Proposed Revised Preliminary Plat & Final Plat

Project Name
Paragon Place

Location
9601 Elderberry Road

Re: 9601 Elderberry Road
Preliminary Plat Comments Dated May 23, 2013

PRELIMINARY PLAT

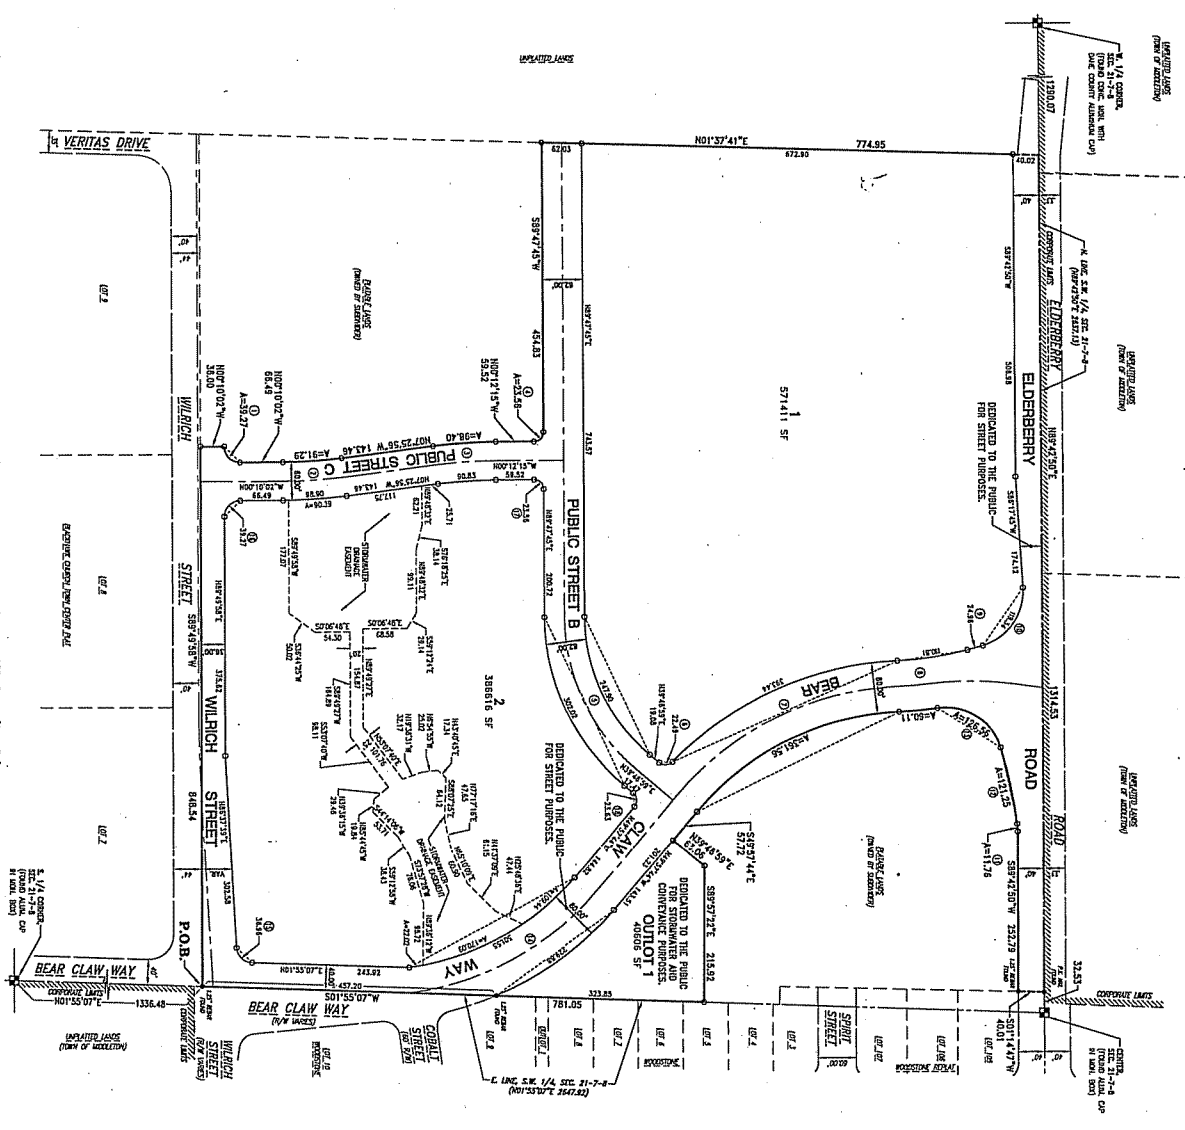
- a. Outlot 2 shall be reoriented to not parallel Bear Claw Way; Planning and City Engineering staff believe that the stormwater outlot could be turned perpendicularly into proposed Lot 6 to allow future buildings on that lot to be

placed closer to Bear Claw Way without impacting the stormwater management requirements for the development;

Outlot 2 has been removed from the plat and replaced with a stormwater drainage easement that encompasses a two-tiered pond. As requested, this pond has been turned perpendicularly from the original orientation to allow the proposed buildings on Bear Claw Way in Lot 6 to be placed closer to Bear Claw Way.
